MARK-UP OF SECTION 96 INCLUSIONS

16.07.2015 - 29.07.2016	A	DEVELOPMENT APPLICATION ISSUE SECTION 96 ISSUE	Morris Goding Elisa Moechar Phone: 9692 8000 Email: elisa@mgac.com.au	MDA Australia Damon Bissell Phone: 400 444 410 Email: damon@mda-aust.com.au	Chris Medland Phone: 9437 4611 Email: chris@medlandmetropolis.com.au	Brian Clarke Phone: 9437 4611 Email: brian@wilkinsonmurray.com.au	Tony Henslip Phone: 9211 7777 Email: tony@tmplg.com.au	Glenn Dixon Phone: 9332 3601 Email: glenn@360.net.au	WENONA SCHOOL 176 Walker Street, North Sydney NSW 2060 Phone: 9409 4406 Email: hmckenzie@wenona.nsw.edu.au	WENONA PROJECT ARCHEMEDES 255-265 Miller Street, North Sydney NSW 2060 PROJECT NO : 14010	Tonkin Zulaikha Greer Architects 117 Reservoir Street ABN: 4600272349 P: (02) 9215 4900 F: (02) 9215 4901 EMAIL: matilda@tztg.com.au WEB www.tztg.com.au	LEVEL 6 PLAN SCALES 1:100 @A1 PHASE SECTION 96 DRAWING NO A-1008 REVISION A	ABN, AVDB, JH, MW, SB, SD, CW CHECKED PT

16.07.2015 - 29.07.2016	A	DEVELOPMENT APPLICATION ISSUE SECTION 96 ISSUE	Do not scale off drawings. Use figured dimensions only. Report any discrepancies to the architect. These designs, plans, specifications and the copyright therein a

459 M² 59 M² 0 M² GFA LEVEL 3
1:250

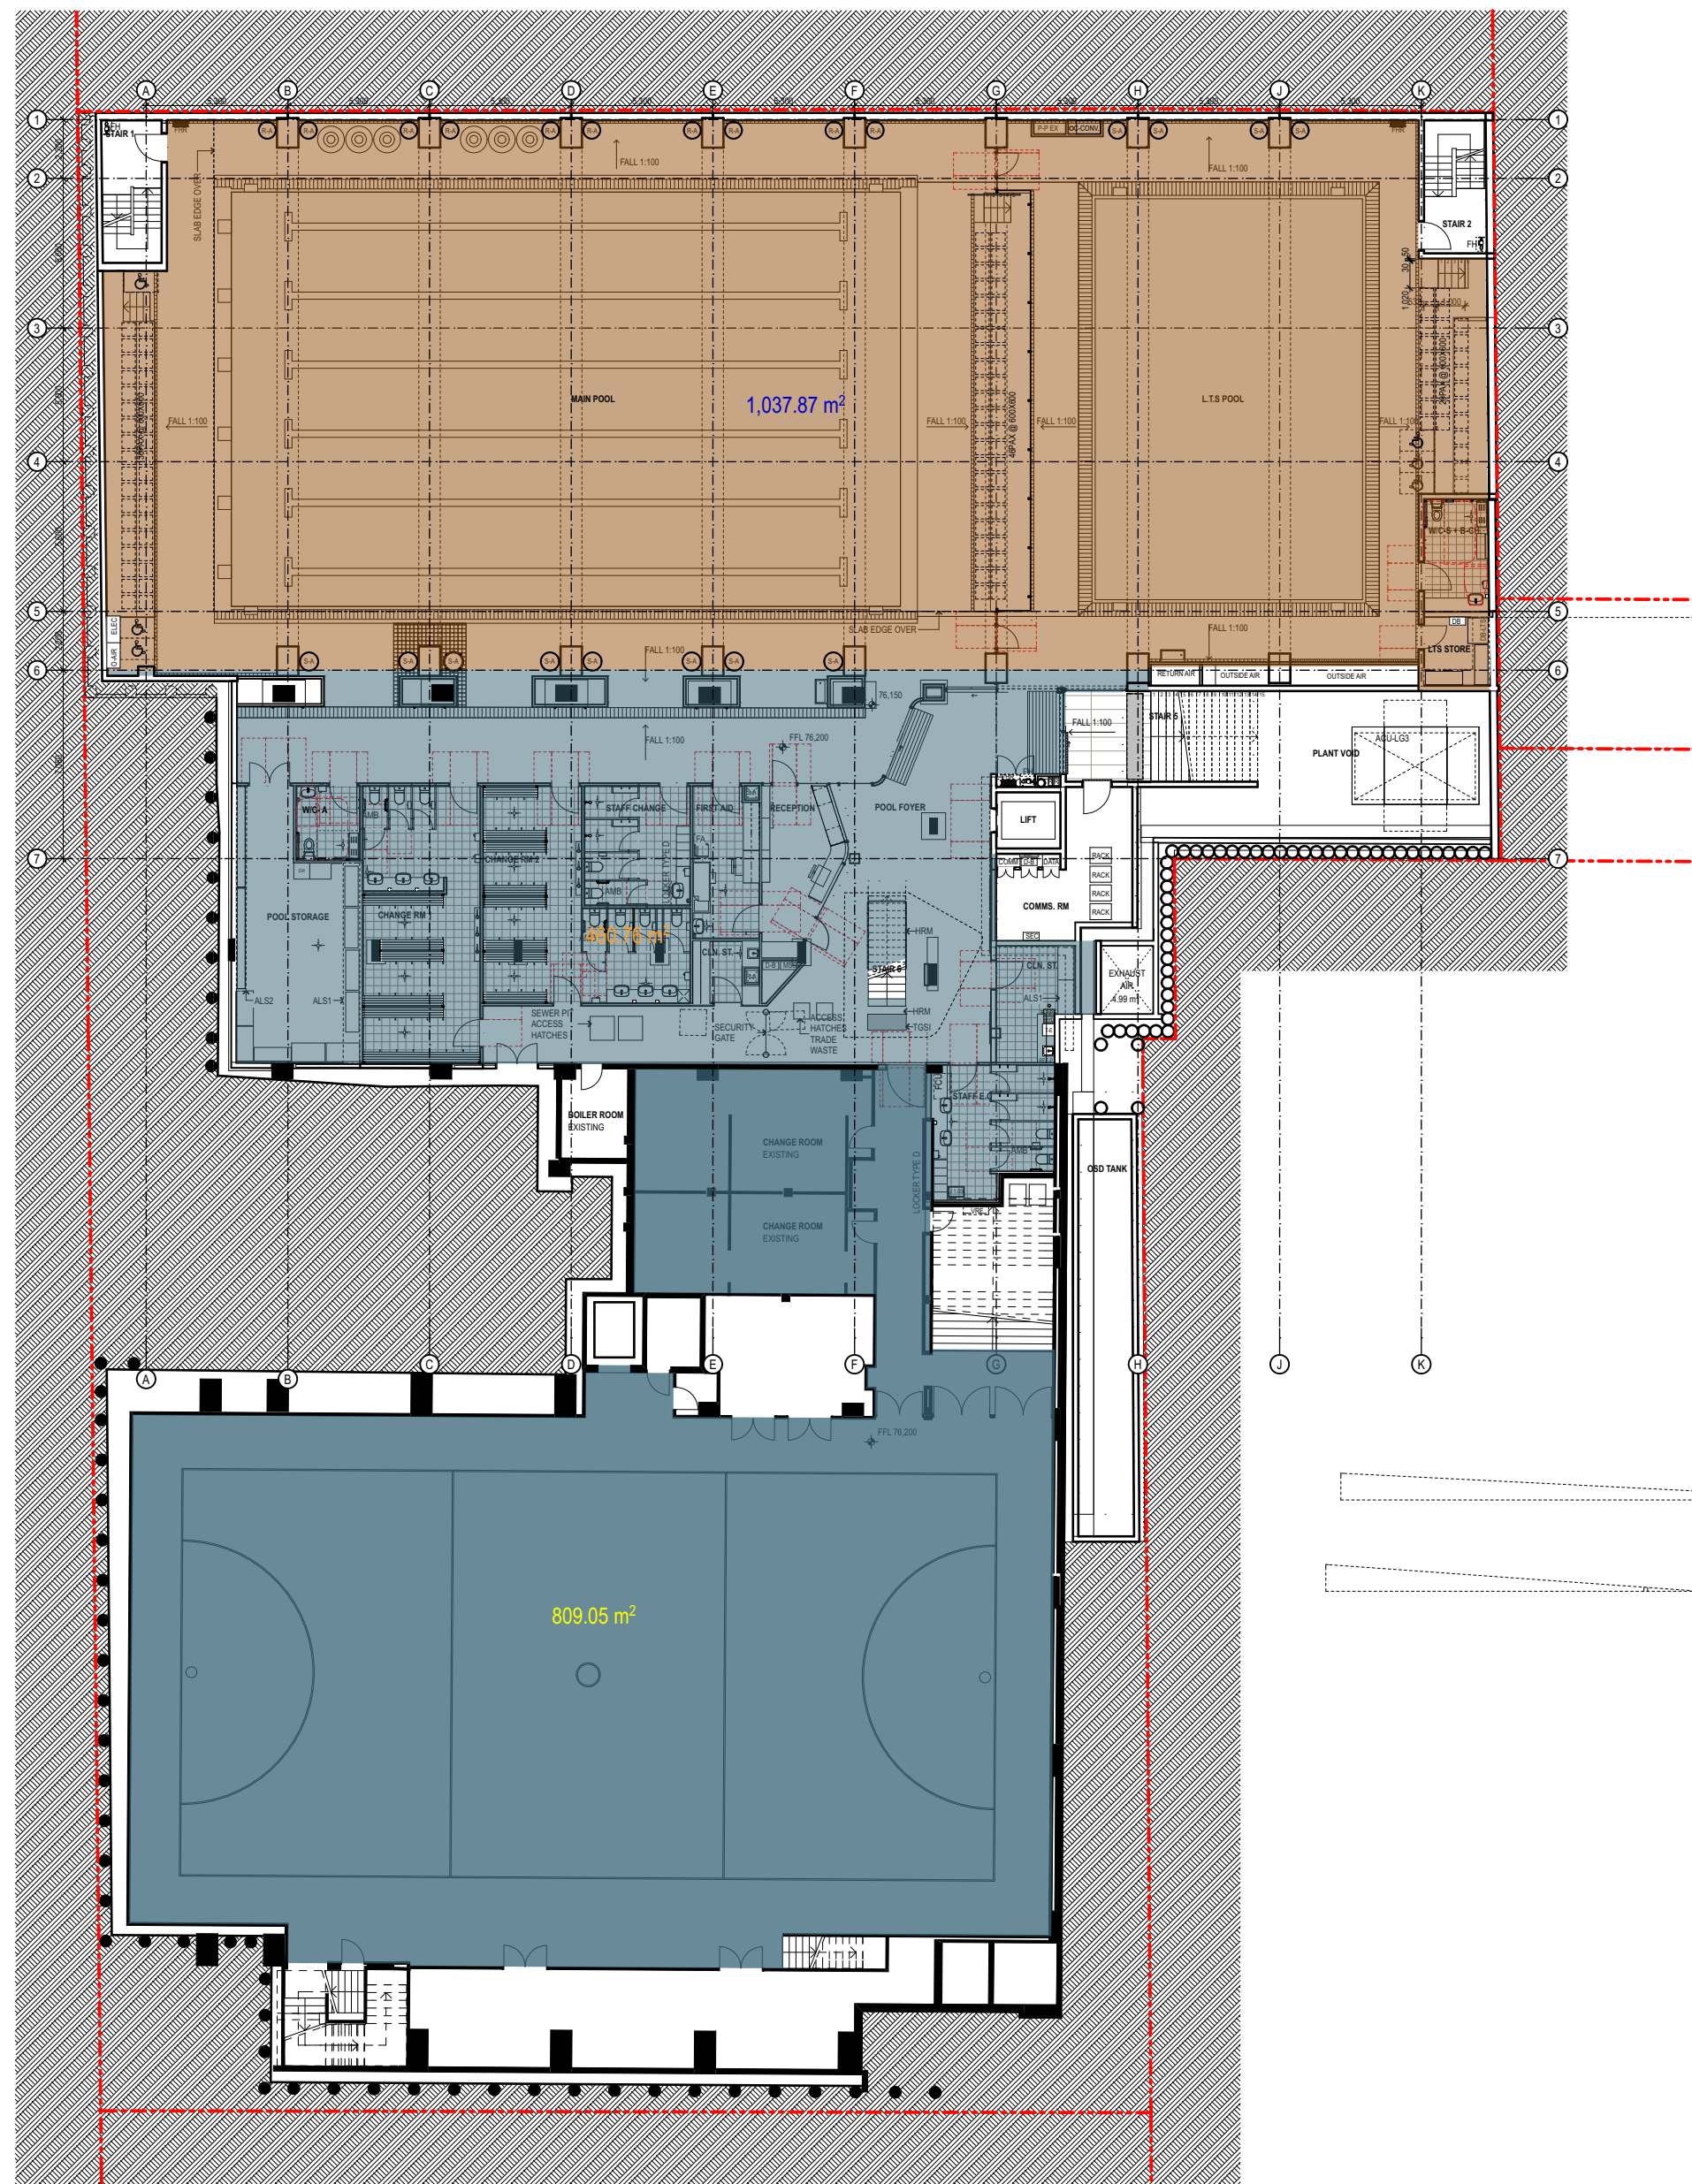
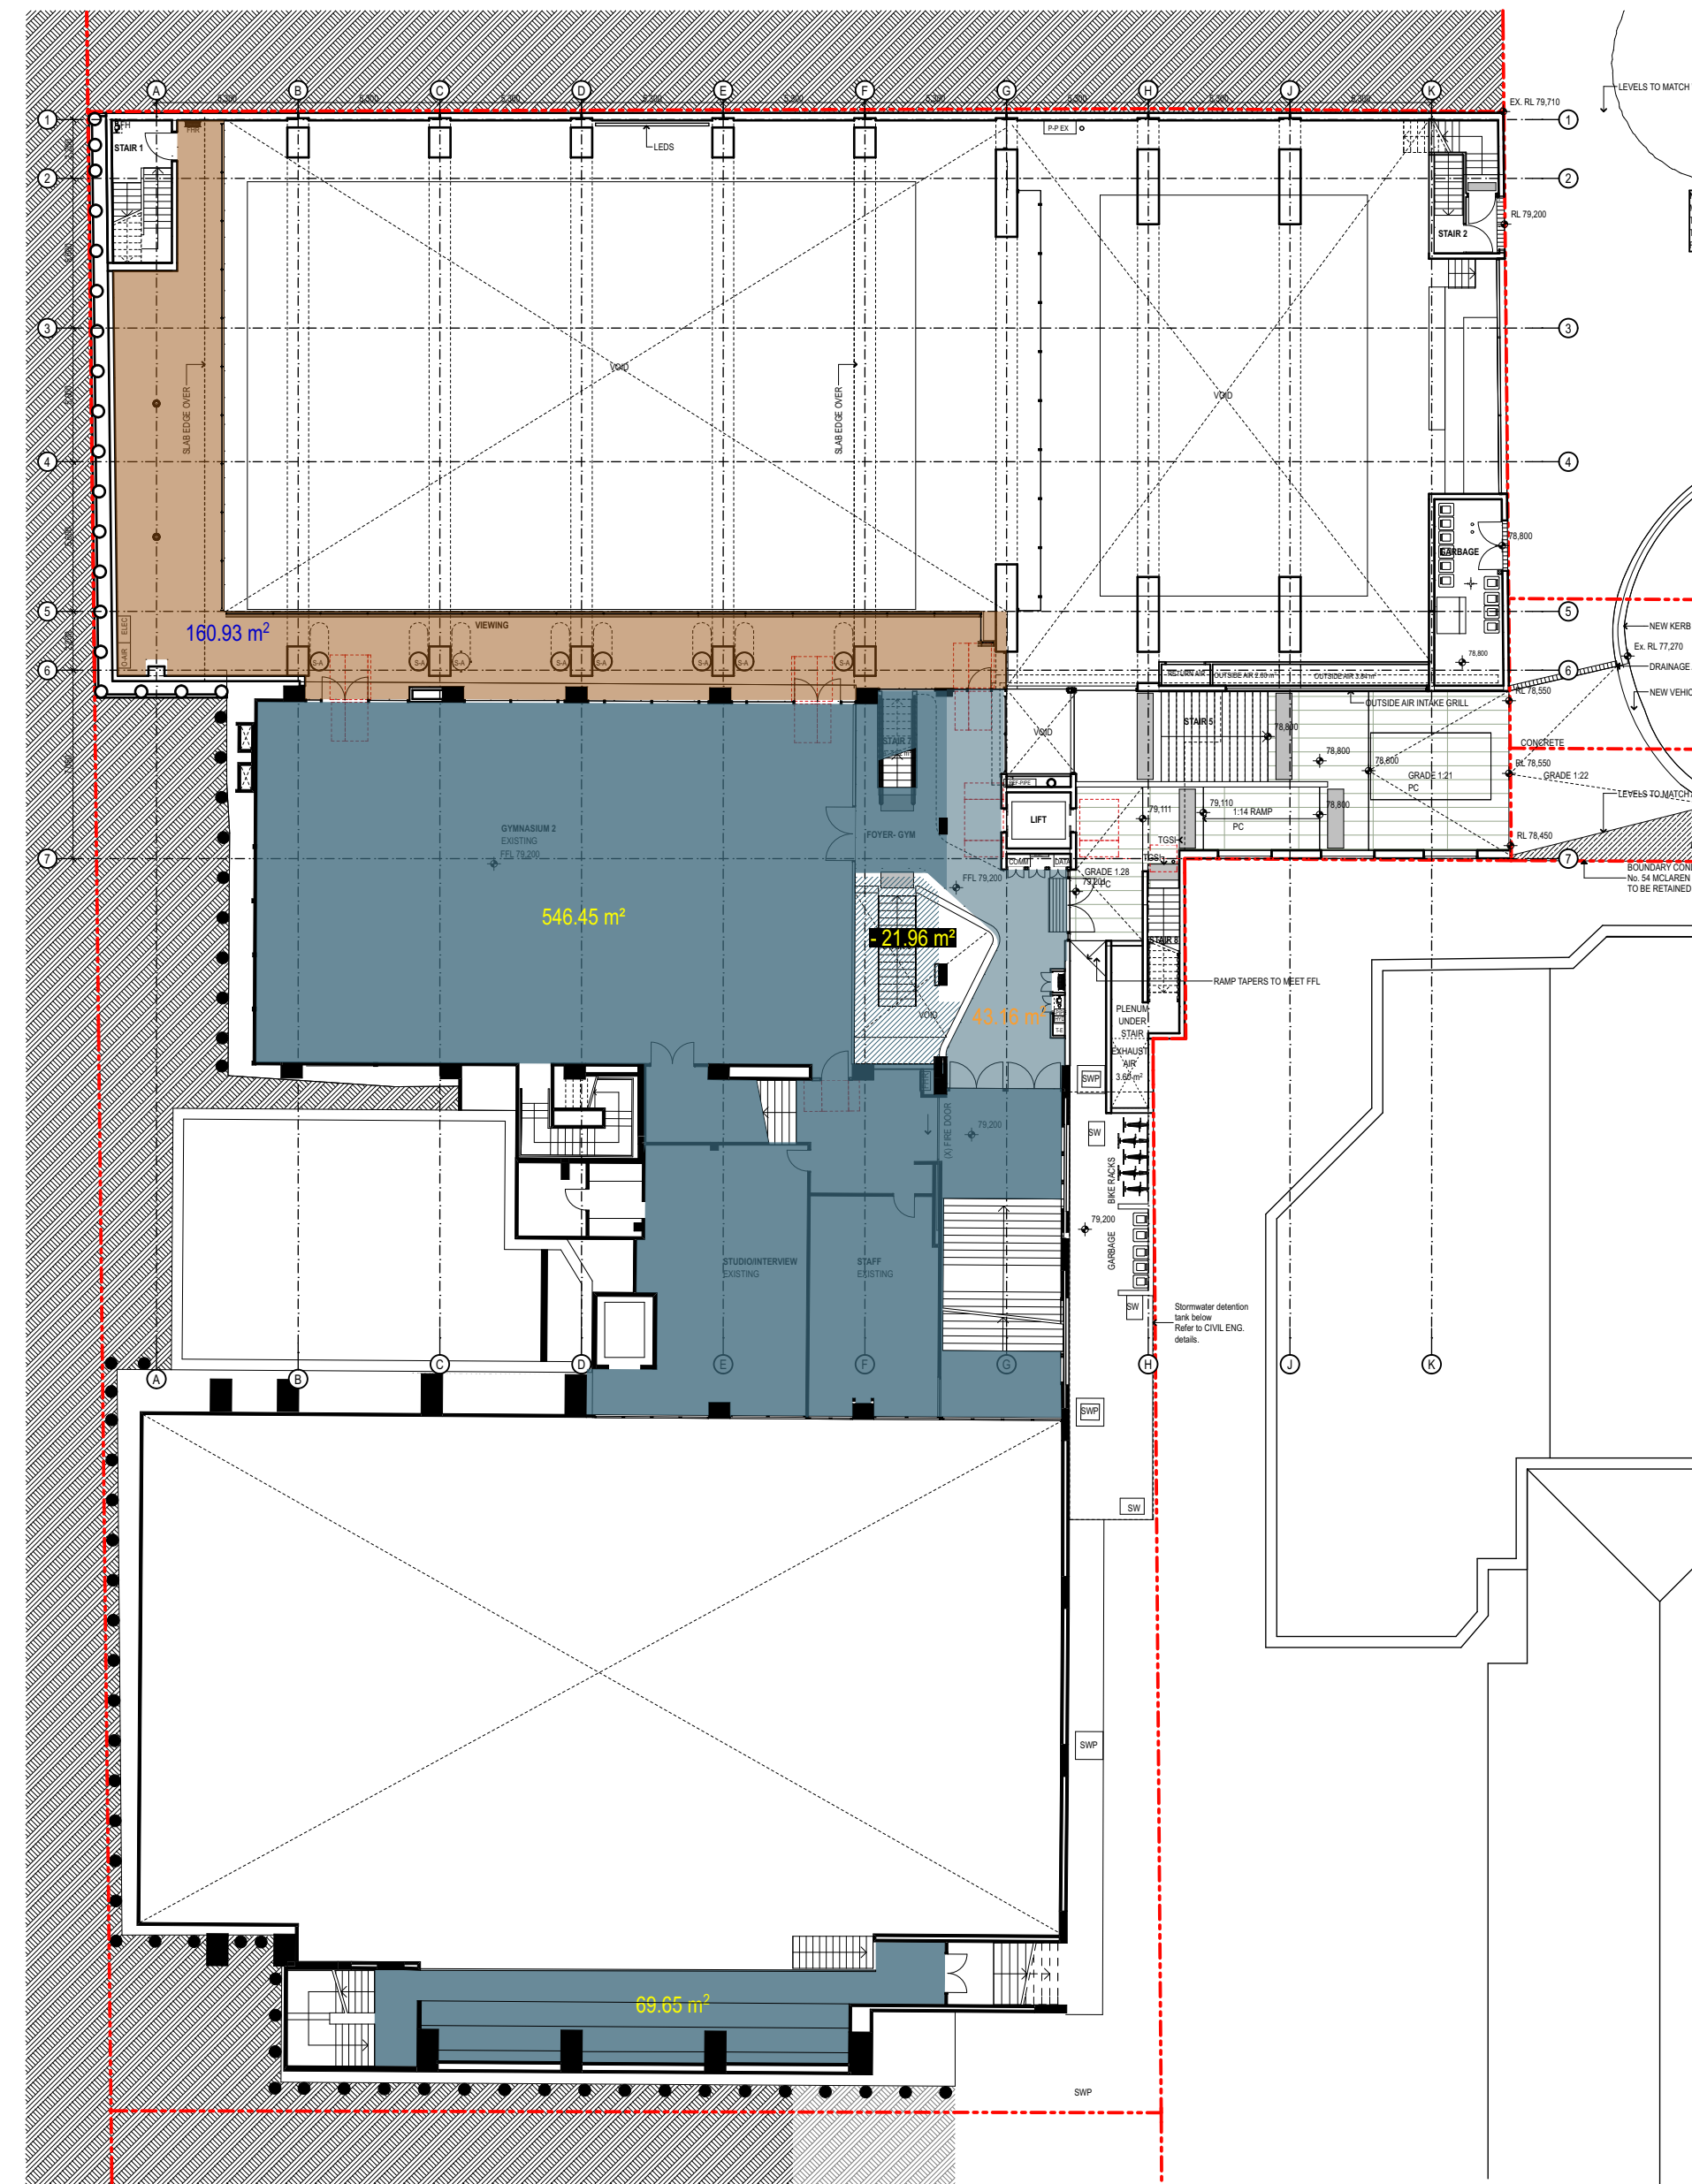
6 GFA/FSR Modification
